ADDENDUM #001

Date: 6/4/2026

Blair Community Schools
Arbor Park Elementary School
Addition and Renovation
1717 Adams Street, Blair, Nebraska 68008

JJA Project: 3670
Drawings & Specifications
Dated: 5/18/2026

MD2.1

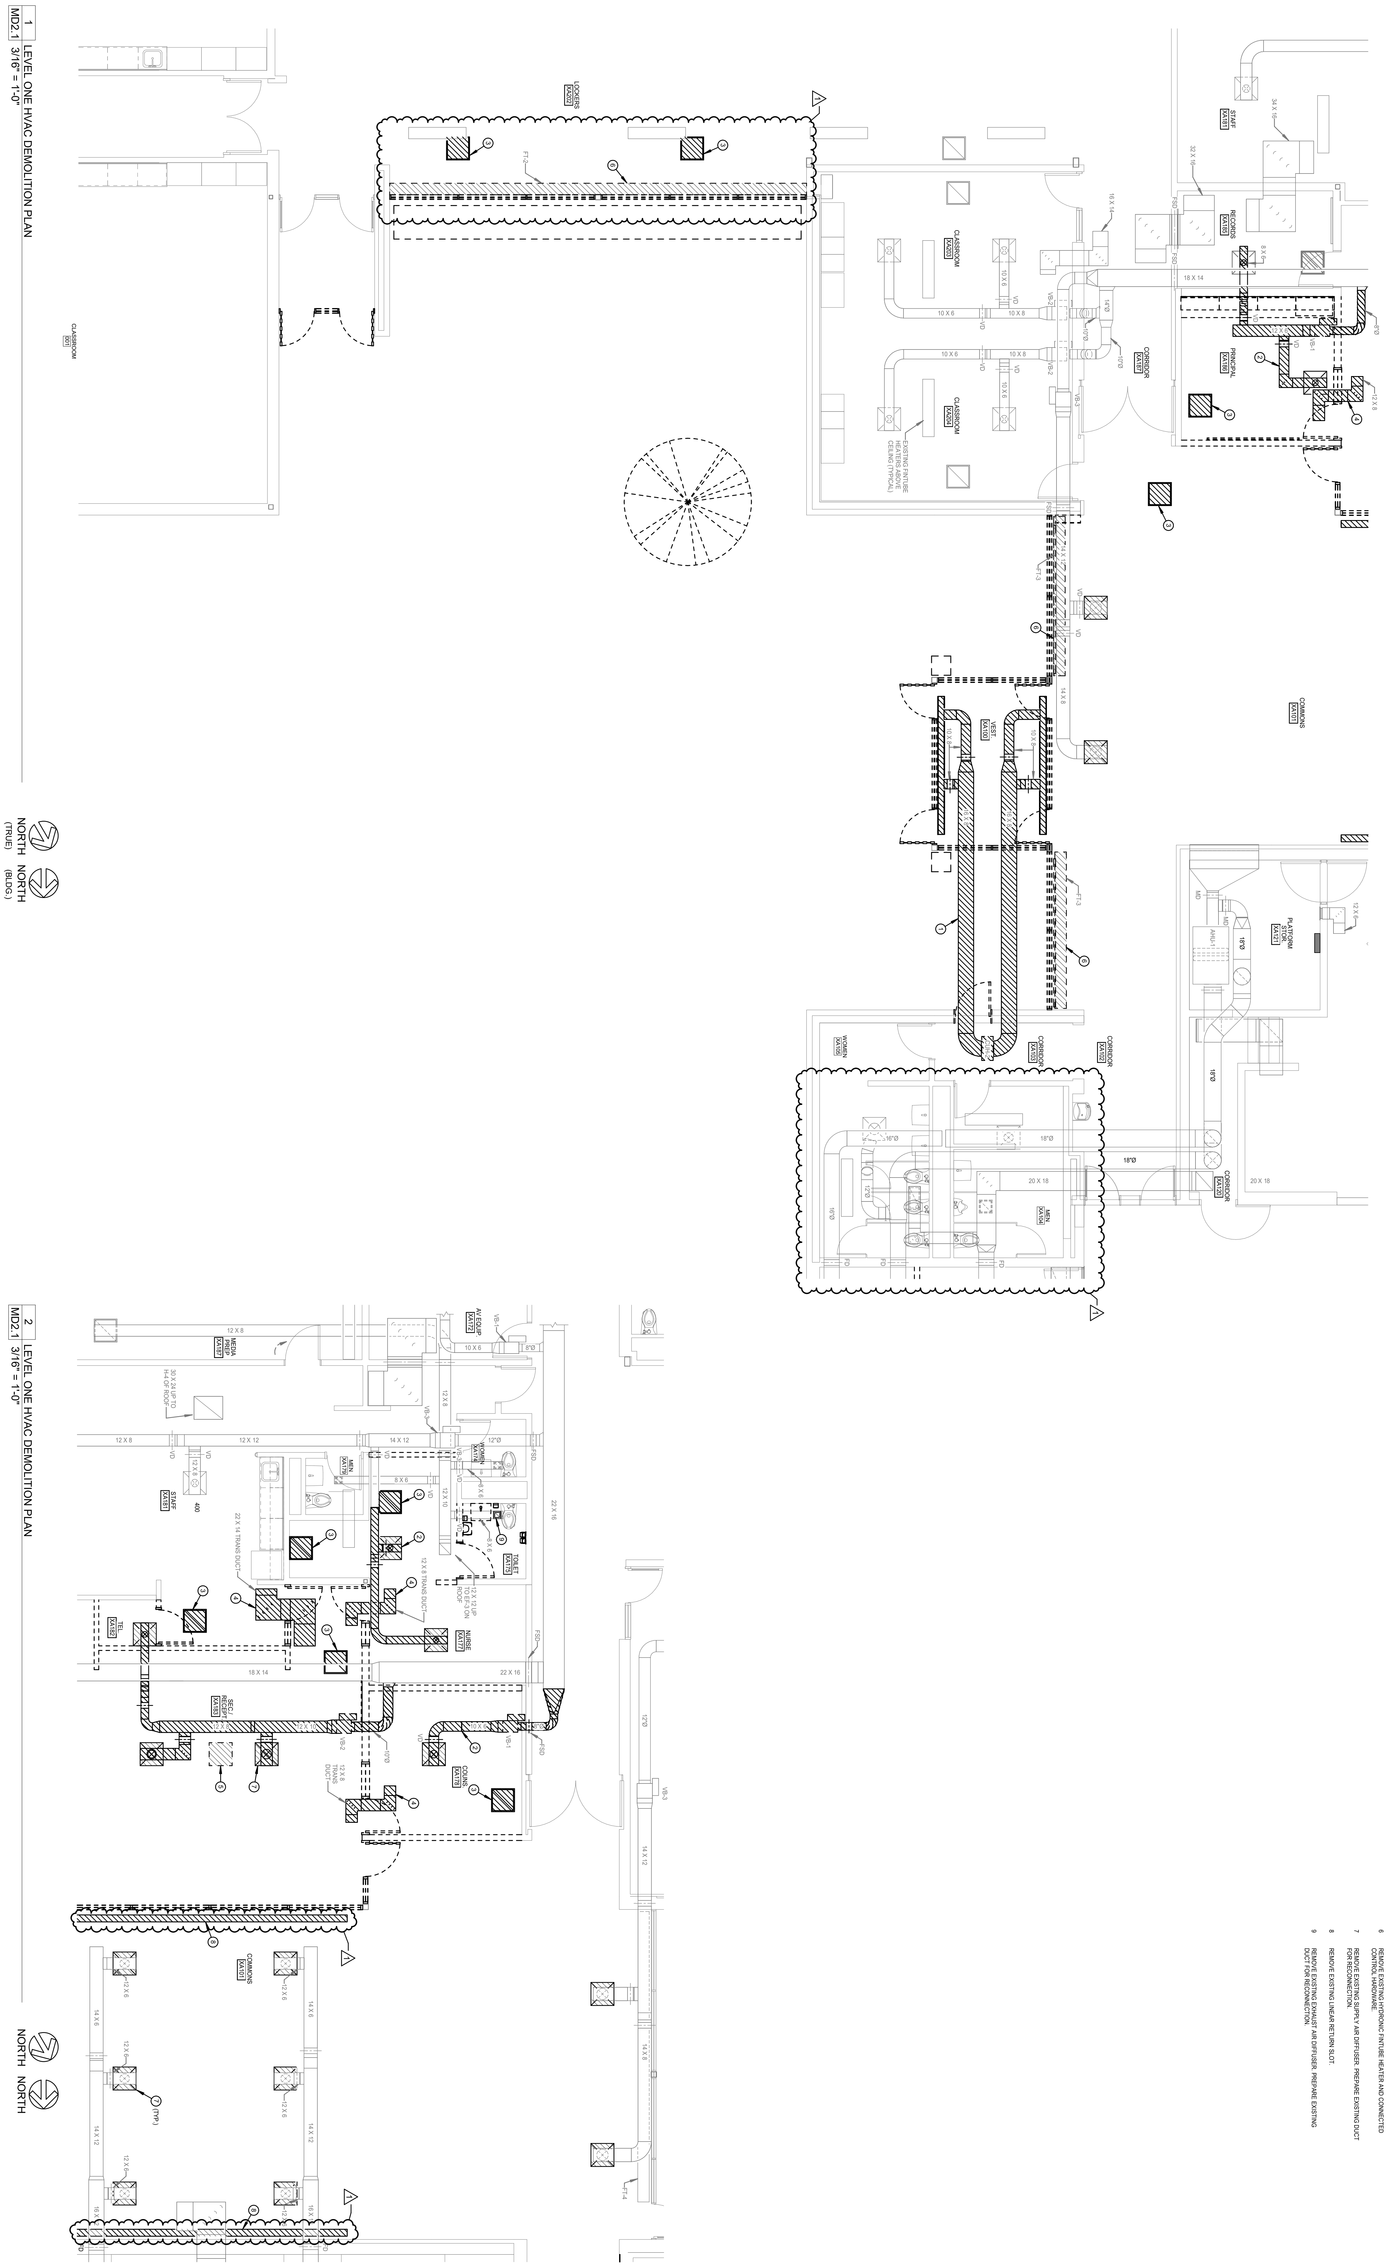
Item #39 Refer to Drawing MD2.1 Level One HVAC Demolition Plan and the attached revised drawing sheet.
A. Updated existing HVAC layout in Mens and Womens Restrooms.
B. Updated existing linear diffusers to be removed.

1 LEVEL ONE MECHANICAL DEMOLITION PLAN
MD3.1 3/16" = 1'-0"

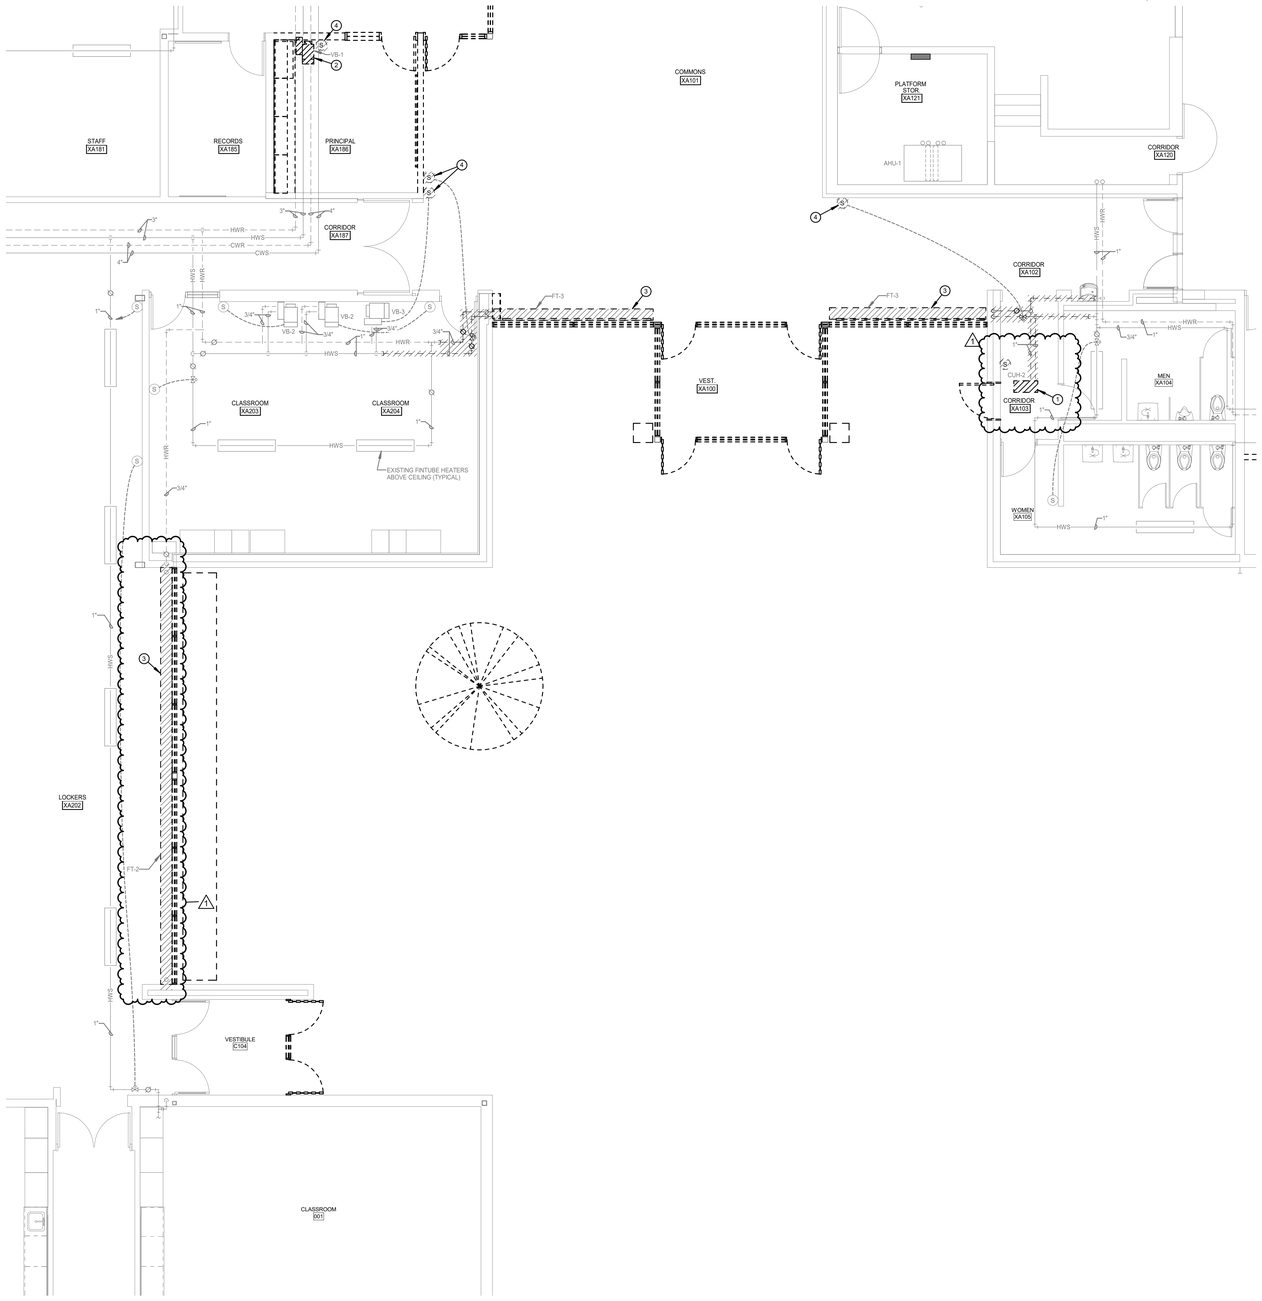
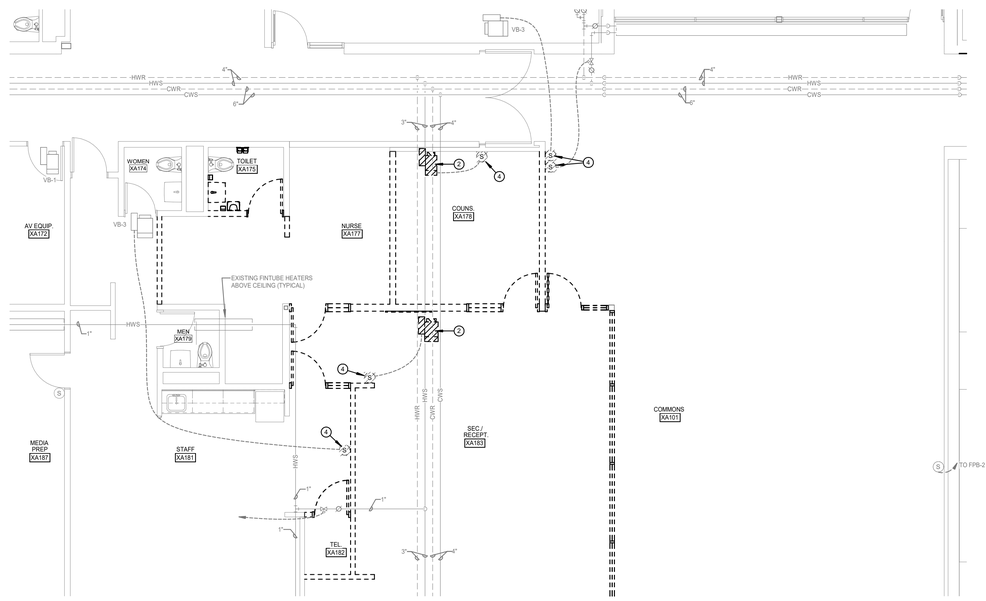
Item #40 Refer to Drawing MD3.1 Level One Hydronic Demolition Plan and the attached revised drawing sheet.
A. Updated existing fin tube heater to be removed.
B. Relocated existing sensor.

1 M2.2 ROOF MECHANICAL PLAN
1/8" = 1'-0"

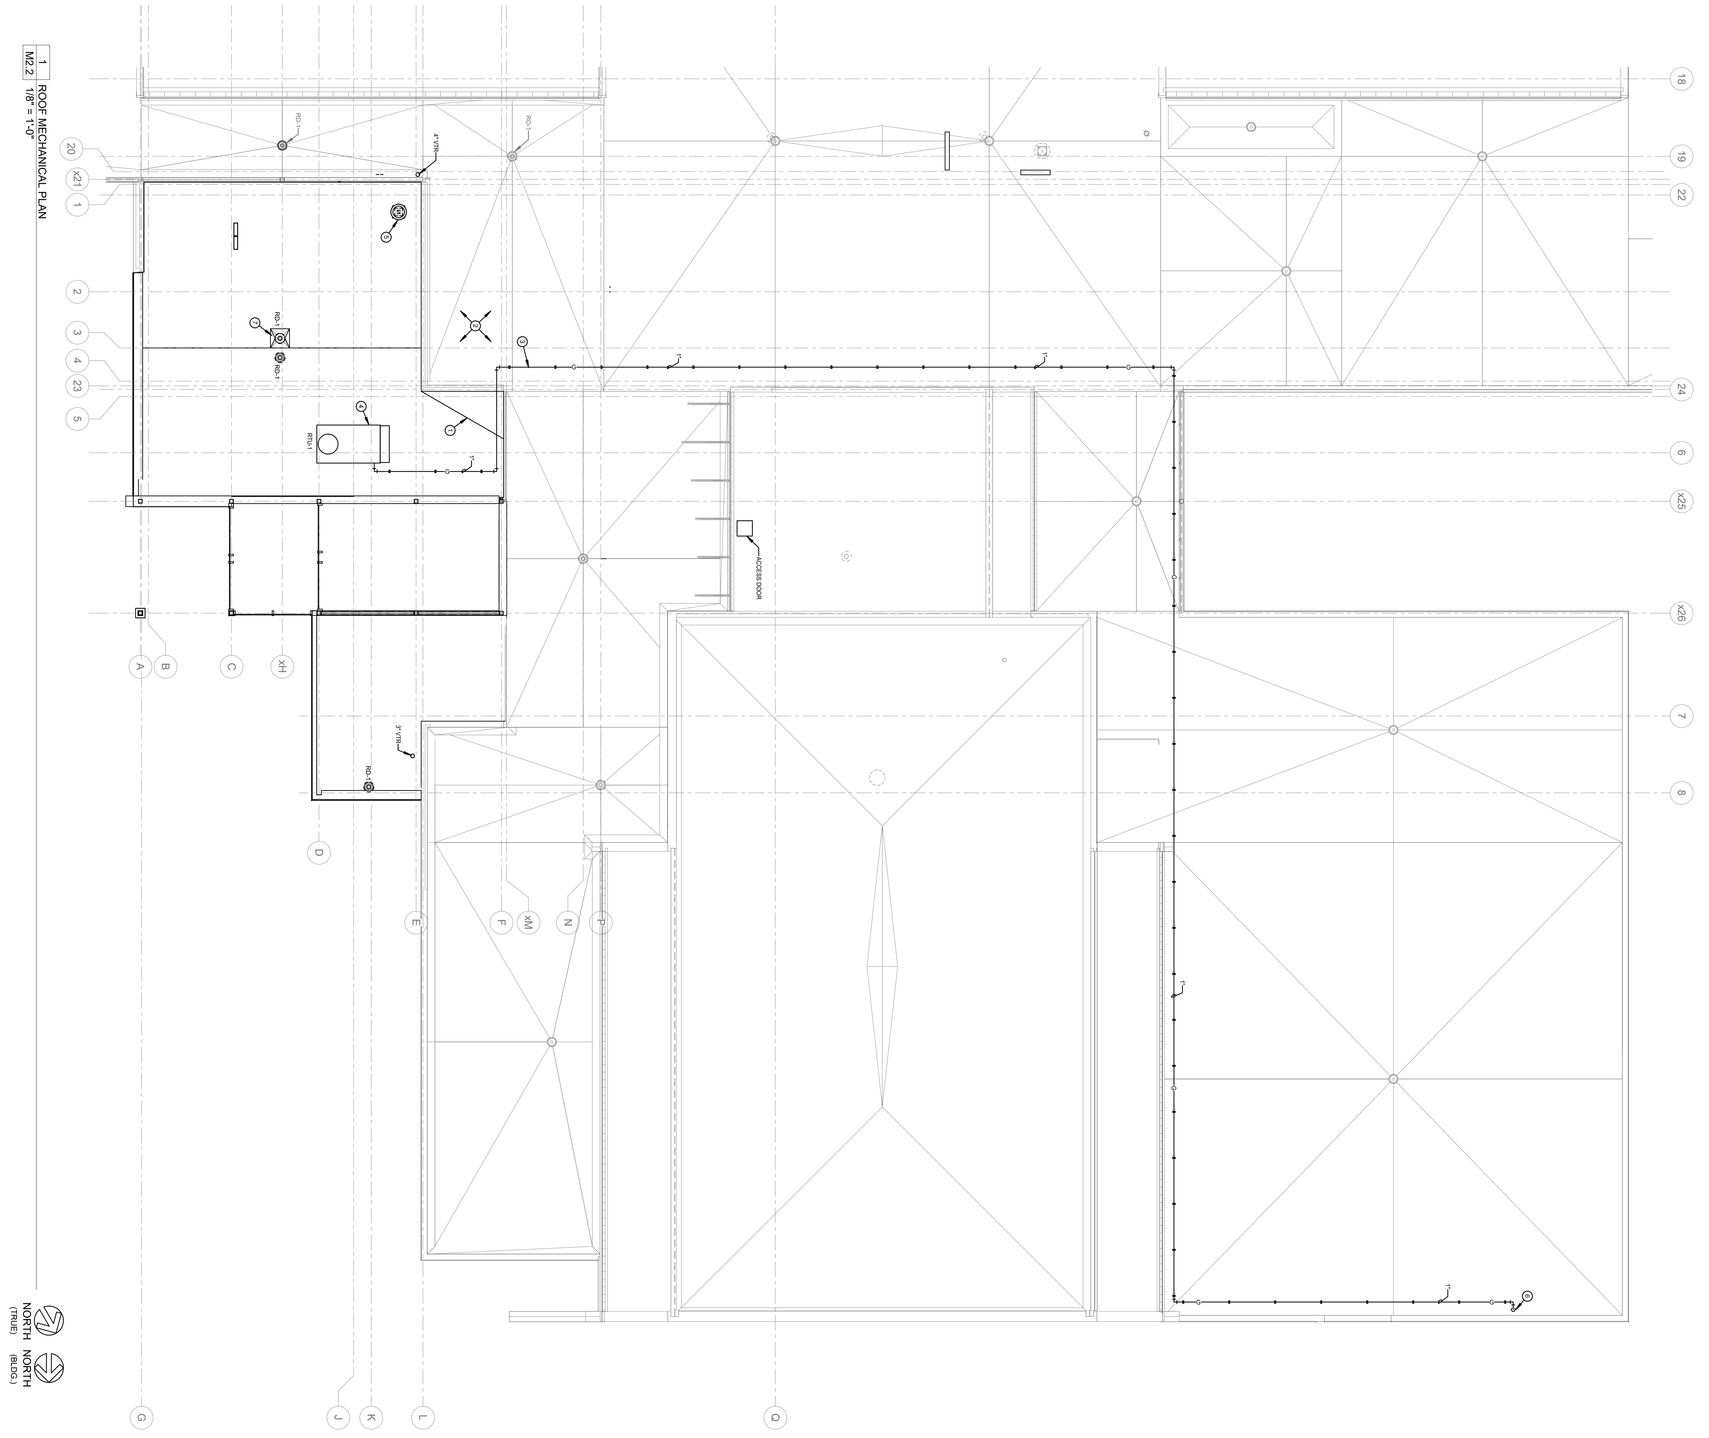
Item #42 Refer to Drawing M2.2 Roof Mechanical Plan and the attached revised drawing sheet.
A. Updated sheet note.

M6.1

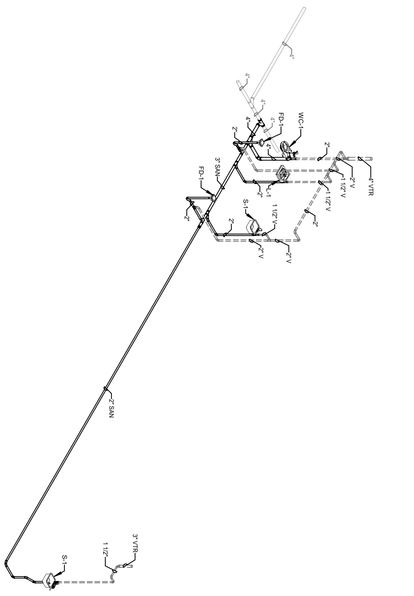
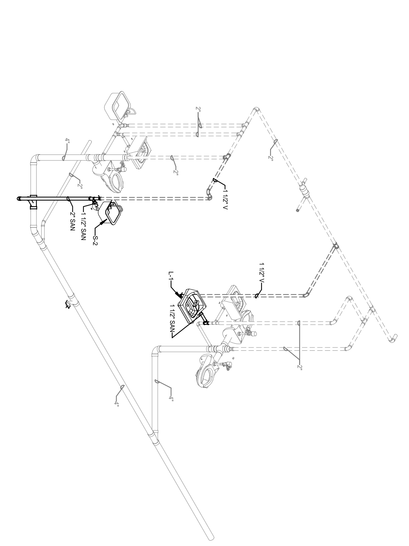
Item #43 Refer to Drawing M6.1 Mechanical Risers and the attached revised drawing sheet.
A. Clarified plumbing risers.
